Meridian Firs Apartments Deck Repair

Casey + DeChant Architects, LLC Architecture And Planning

(Construction Plans, Sheet A1.1)

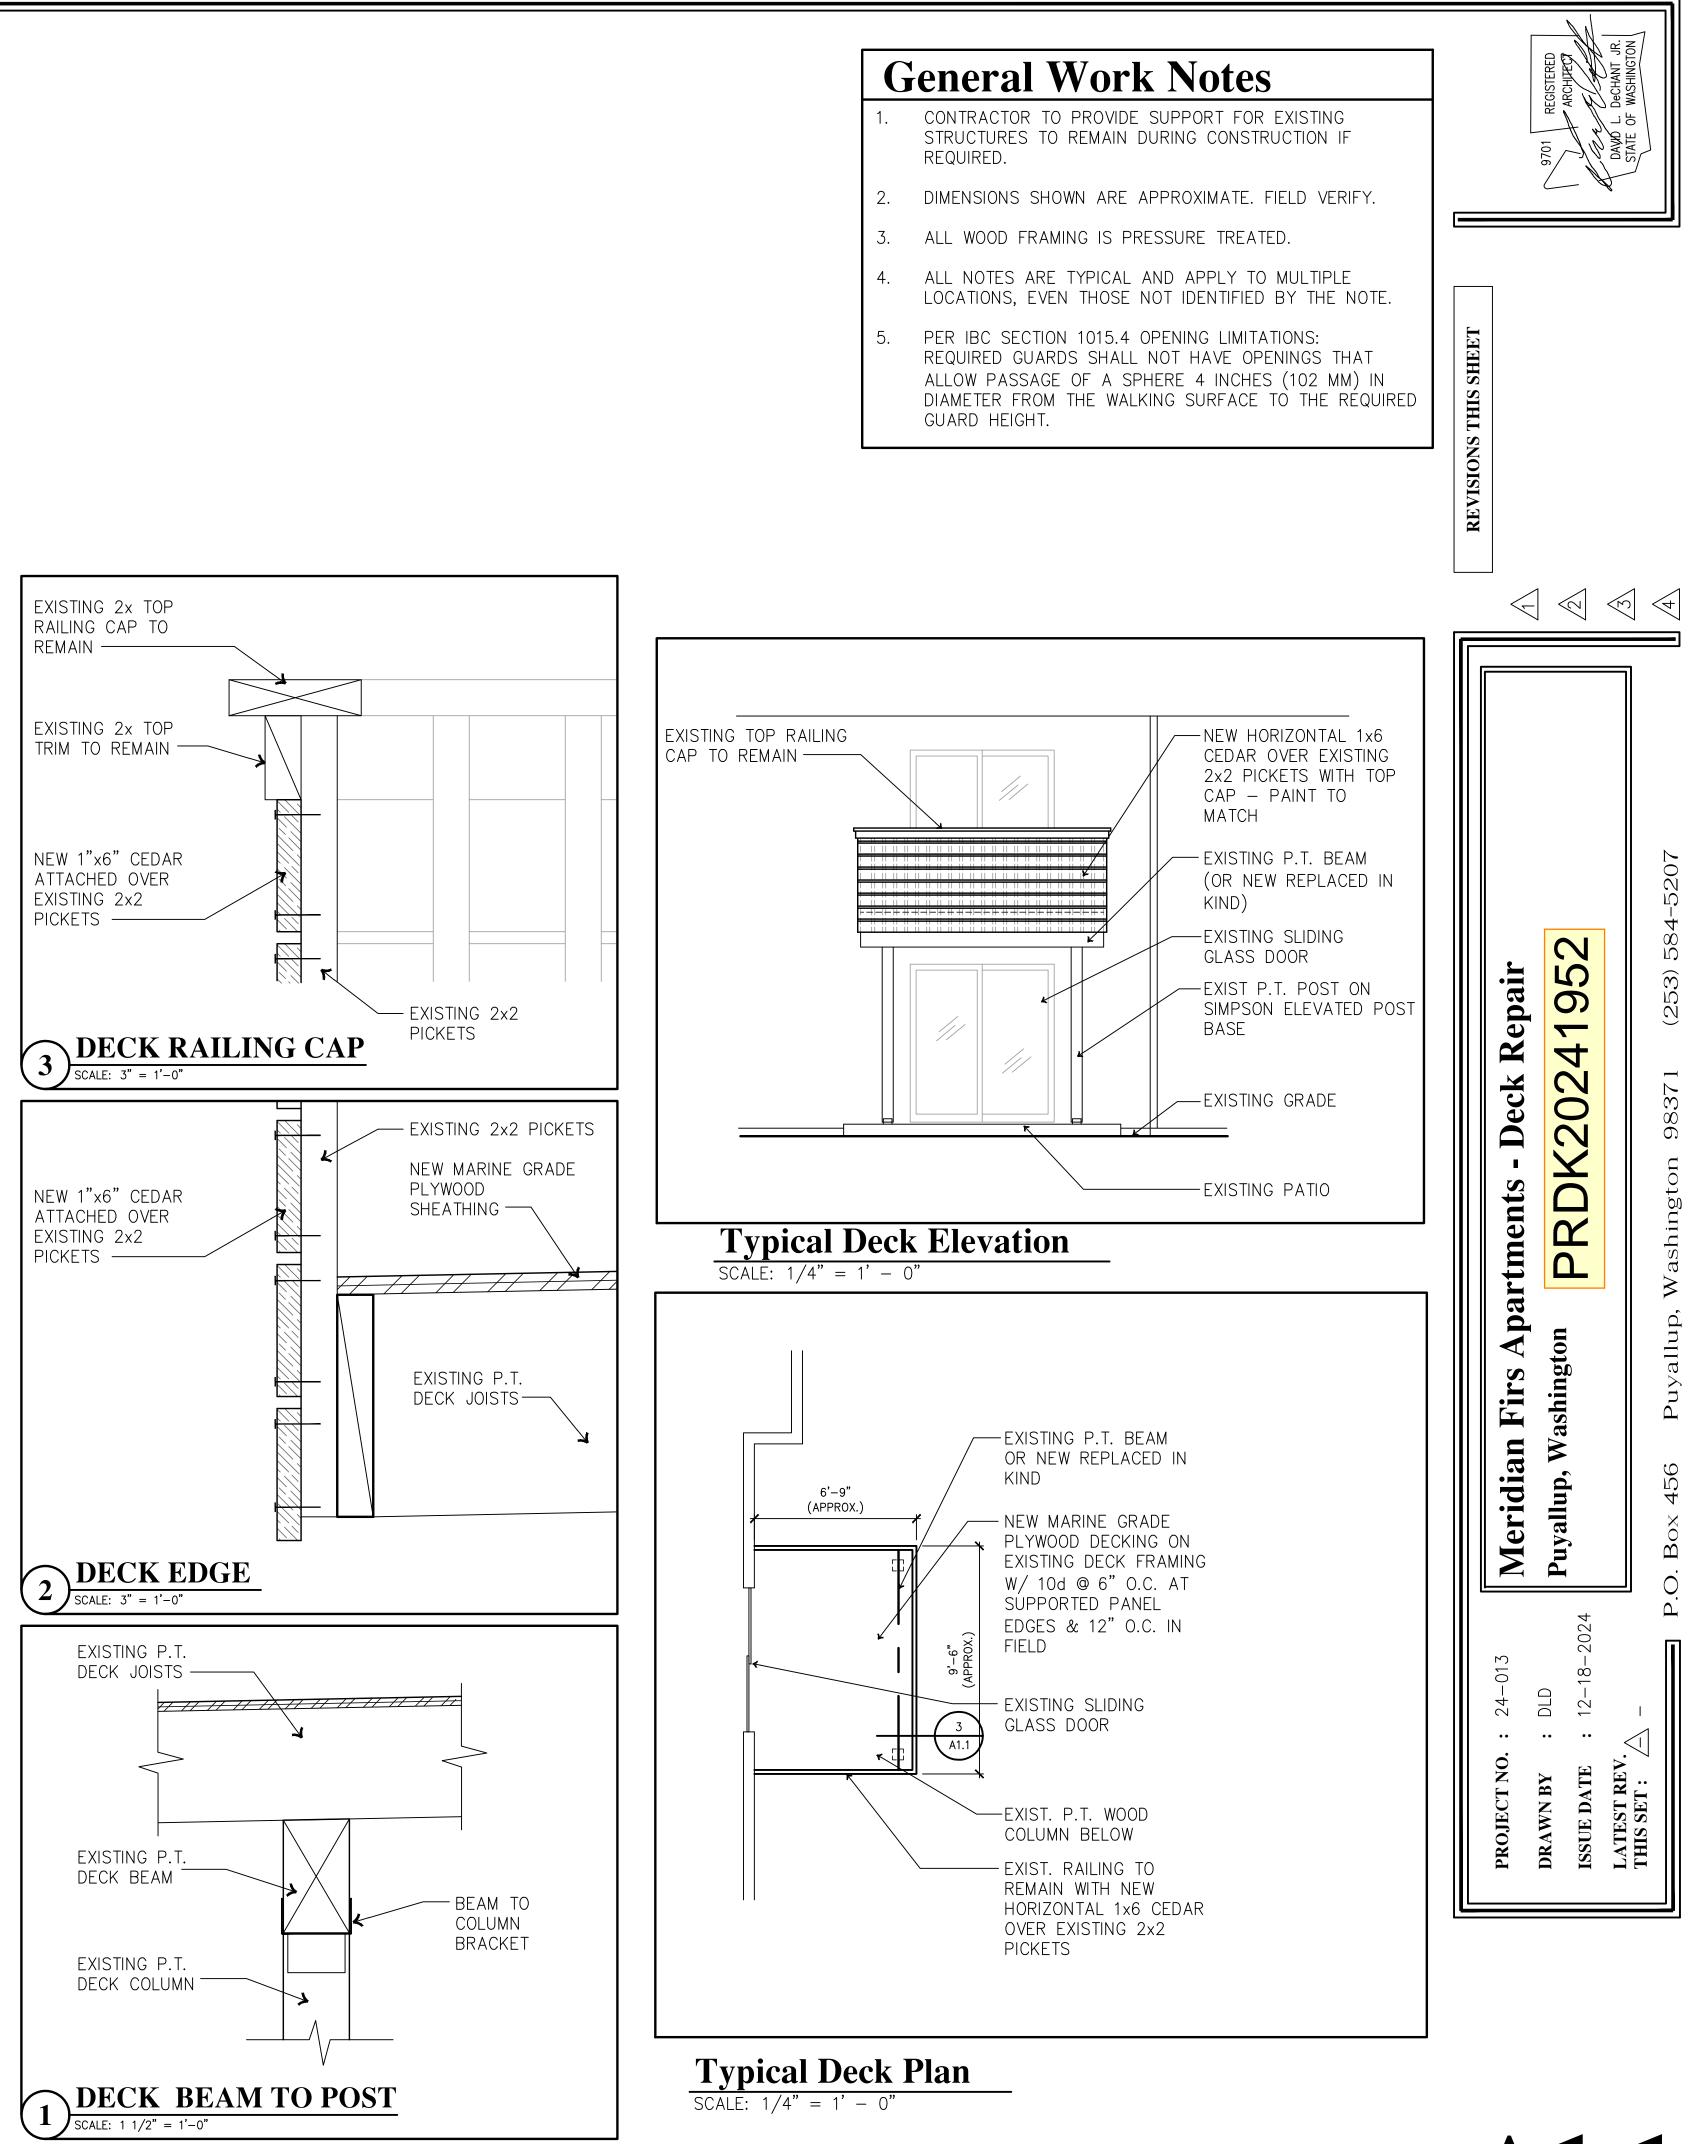
Determine the minimum required specifications for deck beams, posts, post bases, post caps and footings if replacements are necessary. Given the work already completed and the stop-work order in place, establish a clear benchmark to assess the completed work and provide clarity for future construction and inspection, minimizing any potential ambiguities.

Deck joists appear to be sloped to drain off of the cantilevered side of each deck based upon details 1 and 2. Detail 2 shows the installation of the 1x6 cedar board over the existing 2x2 balusters. detail or notate how the 1x6 cedar will be installed to prevent drainage and water accumulation on the deck surface.

Add a notation on either Sheet A1.0 or A1.1 that contractor shall verify the integrity of balusters prior to the installation of the 1x6 cedar. Establish the parameters of the balusters replacement to include type, grade and nailing pattern.

Updated all details and notes as needed to reflect the requested information.
